Bates West Flooring Replacement Project

University of South Carolina
Project Number: 50003340-2
Project advertised: March 14, 2019

ADDENDUM NO.2

April 2, 2019:

ID2.3A
SECTION DETAIL -
APARTMENT
BATHROOM - THRESHOLD
AND FLOORING
TRANSITION

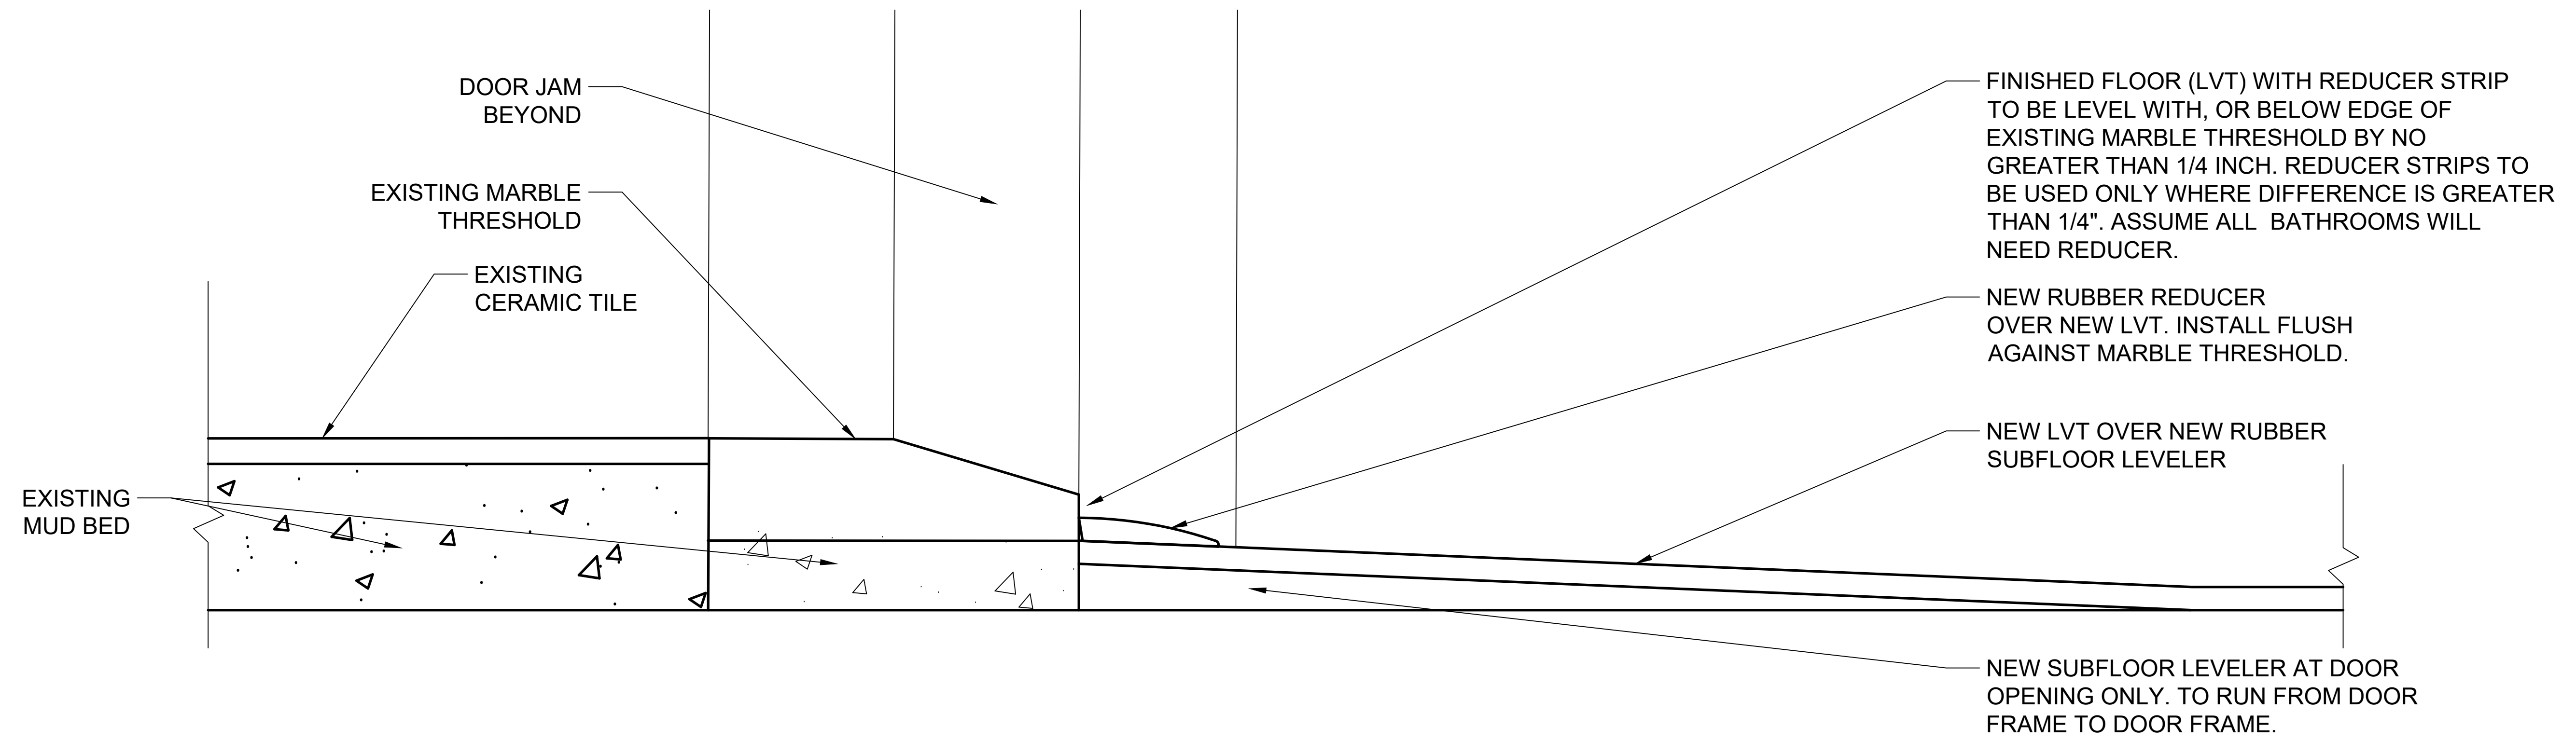
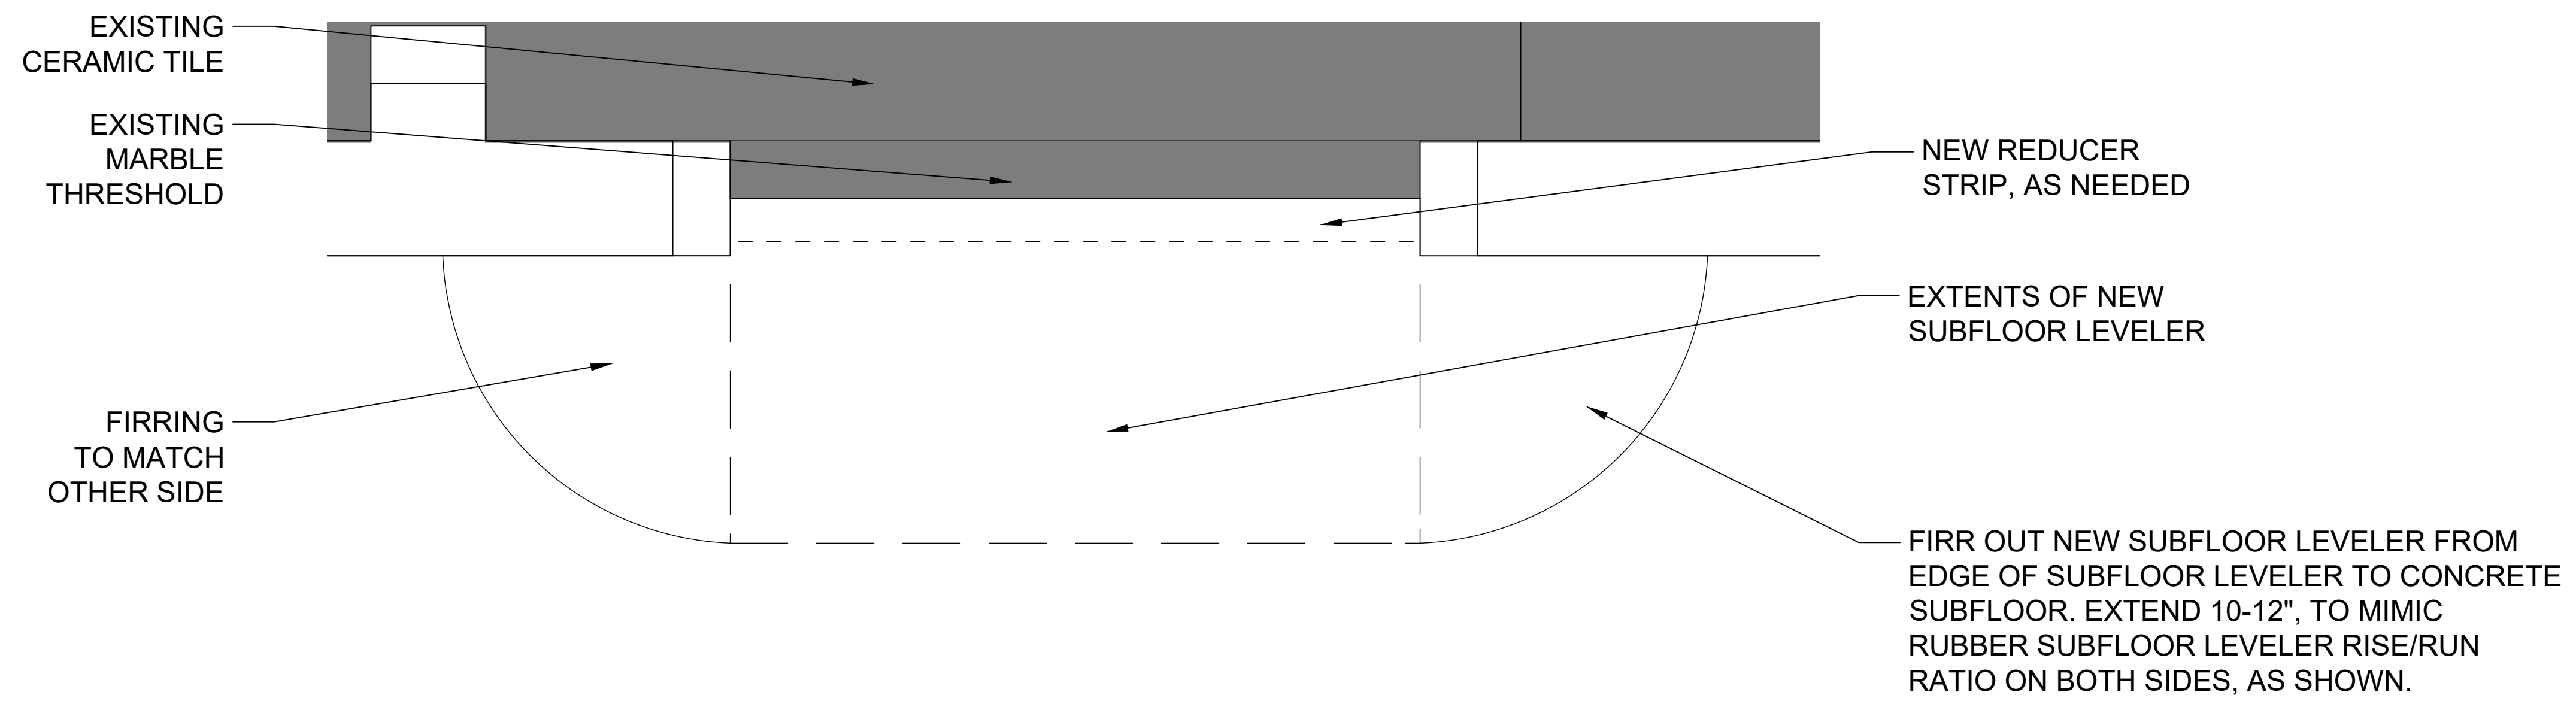
2. The transition area going into the bathroom doesn't allow enough room to slope it in the hallway to level off the way the drawings show. If we are still to raise the flooring to meet the tapered section of the marble threshold, what is going to be an acceptable hump in the floor in the hallway?

Response: Refer to revised drawings ID2.3, ID2.3A for details.
